RIVERWOOD ESTATES SUBDIVISION, PHASE THREE, **RESUBDIVISION OF LOT A**

APPLICATION NUMBER 11 DATE December 20, 2007

REQUEST Subdivision

DETAIL SITE PLAN

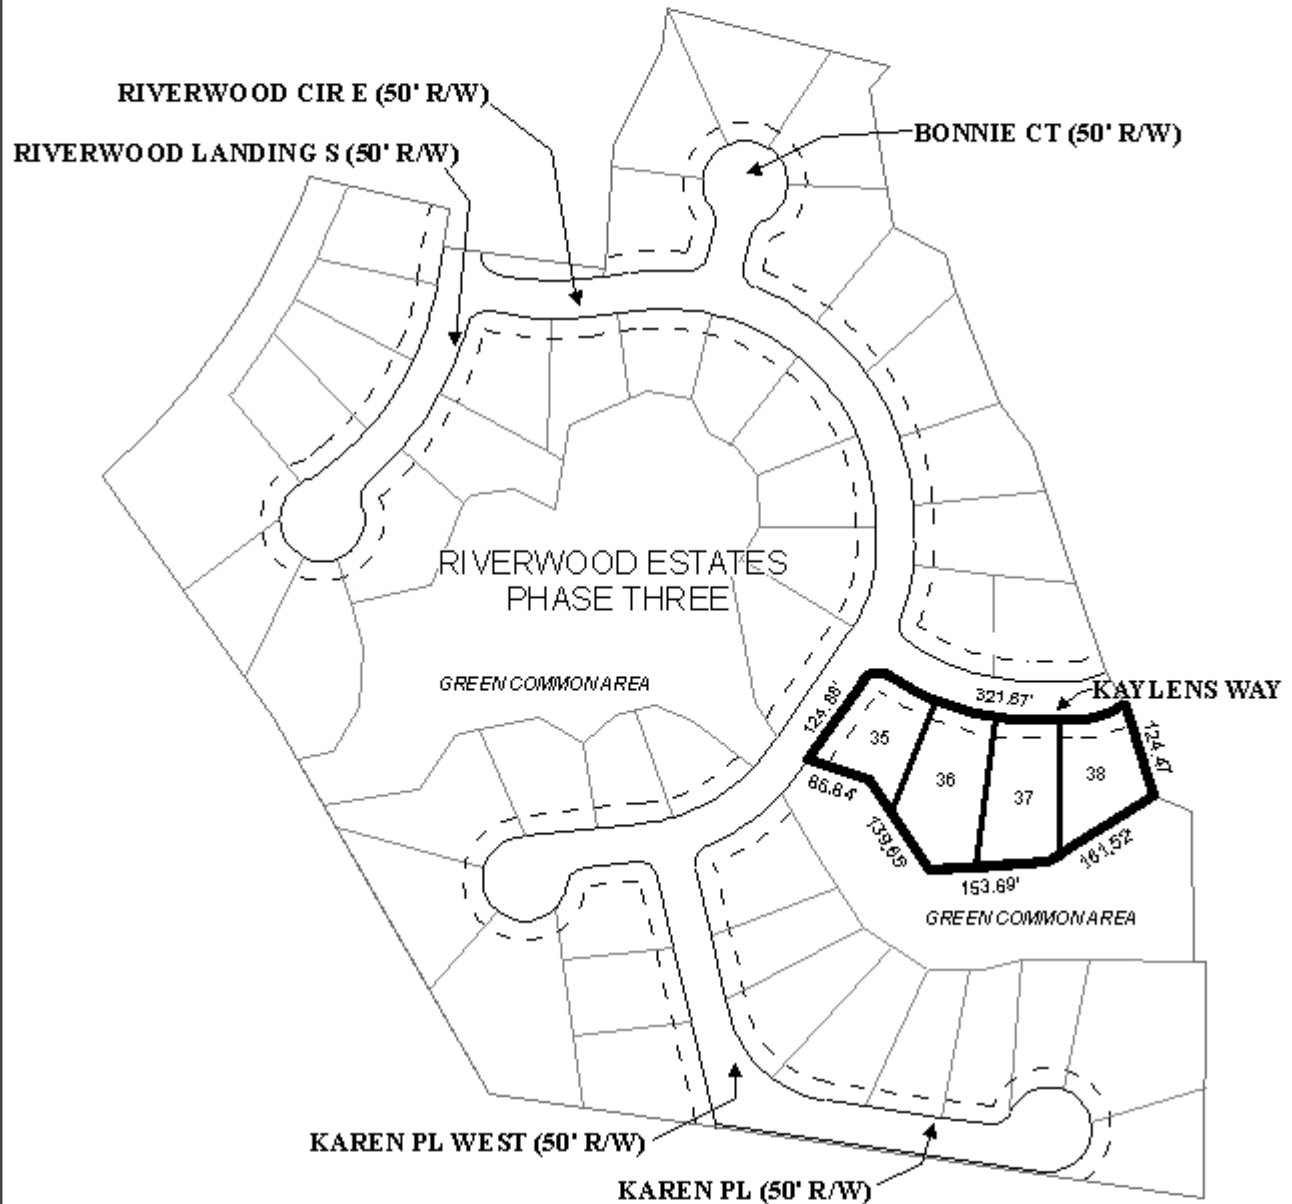
The plat illustrates the proposed 1.6 acre \pm , 4 lot subdivision which is located at the Southeast corner of Riverwood Circle South and Kaylens Way. The applicant states that the subdivision is served by both public water and sanitary sewer.

The site fronts onto Riverwood Circle South and Kaylens Way, both minor streets with adequate rights-of-way. Due to the limited frontage of each lot and a corner lot situation, access management is a concern. A note should be placed on the final plat, if approved, stating that each lot is limited to one curb-cut each, with the size, design and location to be approved by Mobile County Engineering.

Any common areas associated with the development should be labeled, as depicted on the preliminary plat. A note should be placed on the plat stating that all common areas and easements are to be maintained by the property owners association for the development.

The site is located in the County, thus a note stating that any lots which are developed commercially and adjoin residentially developed property must provide a buffer, in compliance with Section V.A.7. of the Subdivision Regulations, should be retained for the Final Plat, if approved.

While the site is in Mobile County, it will have to comply with the City of Mobile storm water and flood control ordinances. A note should be placed on the final plat stating that the development will be designed to comply with the storm water detention and drainage facility requirements of the City of Mobile storm water and flood control ordinances, and requiring submission of certification from a licensed engineer certifying that the design complies with the storm water detention and drainage facility requirements of the City of Mobile storm water and flood control ordinances prior to the issuance of any permits. Certification is to be submitted to the Planning Section of Urban Development and County Engineering.

The plat is recommended for Tentative Approval, subject to the following conditions:

- 1) Placement of a note on the final plat stating that each lot is limited to one curb-cut each, with the size, design and location to be approved by Mobile County Engineering;

- 2) Placement of a note on the plat stating that approval of all applicable Federal, state and local agencies is required for wetland issues, if any, prior to the issuance of any permits or land disturbance activities;

- 3) Placement of a note on the plat stating that approval of all applicable Federal, state and local agencies is required for endangered, threatened or otherwise protected species, if any, prior to the issuance of any permits or land disturbance activities;

- 4) Labeling of all common areas, and placement of a note on the plat stating that all common areas and easements are to be maintained by the property owners association for the development;

- 5) Placement of a note on the plat stating that any lots which are developed commercially and adjoin residentially developed property must provide a buffer, in compliance with Section V.A.7. of the Subdivision Regulations;

- 6) Placement of a note on the plat stating that the development will be designed to comply with the storm water detention and drainage facility requirements of the City of Mobile storm water and flood control ordinances, and requiring submission of certification from a licensed engineer certifying that the design complies with the storm water detention and drainage facility requirements of the City of Mobile storm water and flood control ordinances prior to the issuance of any permits. Certification is to be submitted to the Planning Section of Urban Development and County Engineering; and

- 7) Labeling of all lots with their size in square feet.
